ADDENDUM NO. 1

City of Lincoln, Nebraska (2007)
Antelope Valley Lewis Fields Parking Lot
Project No. 780307
JAVA Project Number 880307
Lincoln Parks & Recreation No. 2007-007
SPECIFICATION NO. 08-016
January 18, 2008

CURB CUT DETAIL
NOT TO SCALE

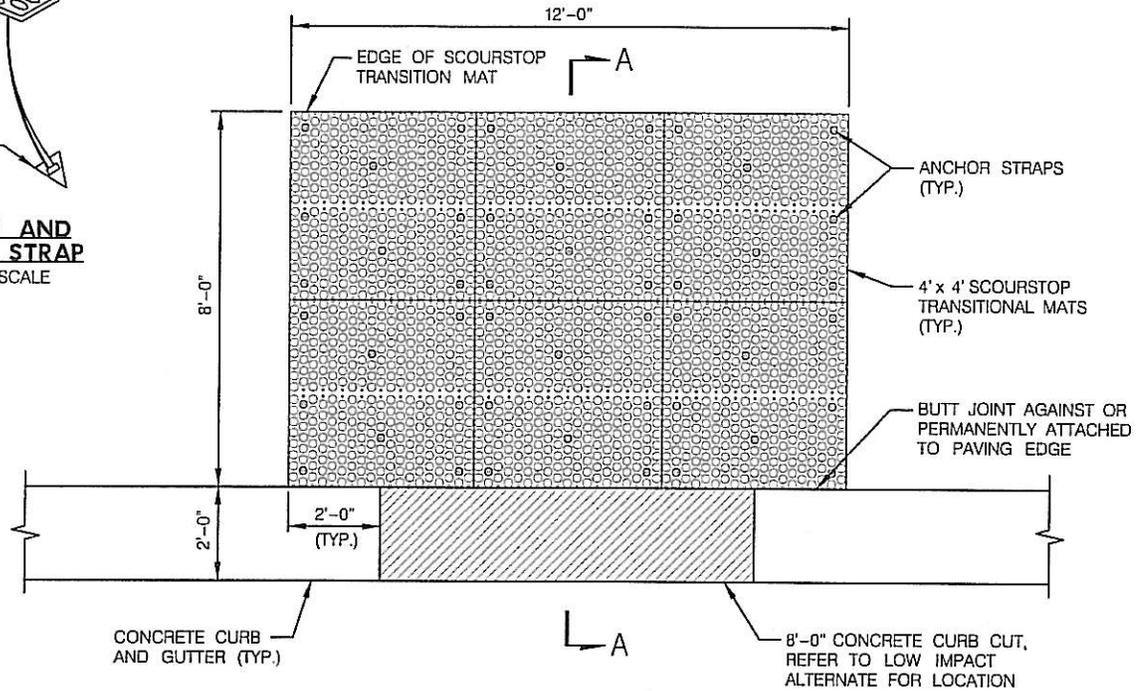
Delete the following details in there entirety: “Curb Cut Detail”, “Modular Block Detail” and “Section A-A” and Replace with the Attached Figure 1.

The Scourstop Transition Mat and Sodding (Complete) will be used at the curb cut for each rain garden location. The design of the Scourstop Mat and Sodding will replace the Modular Block Retaining Wall, River Rock and Landscape Block design.

SECTION A-A
NOT TO SCALE

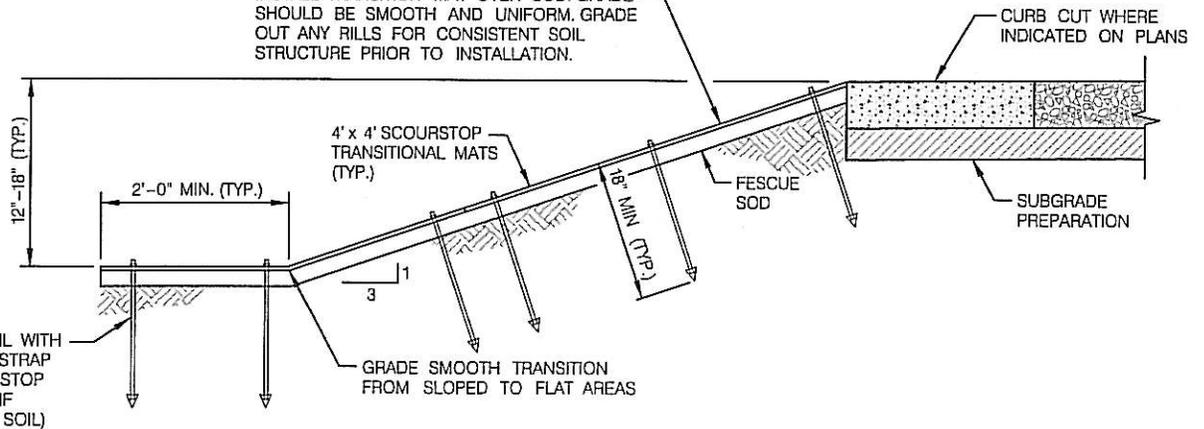
INSTALL TRANSITION MAT OVER SOD GRADE SHOULD BE SMOOTH AND UNIFORM. GRADE OUT ANY RILLS FOR CONSISTENT SOIL STRUCTURE PRIOR TO INSTALLATION.
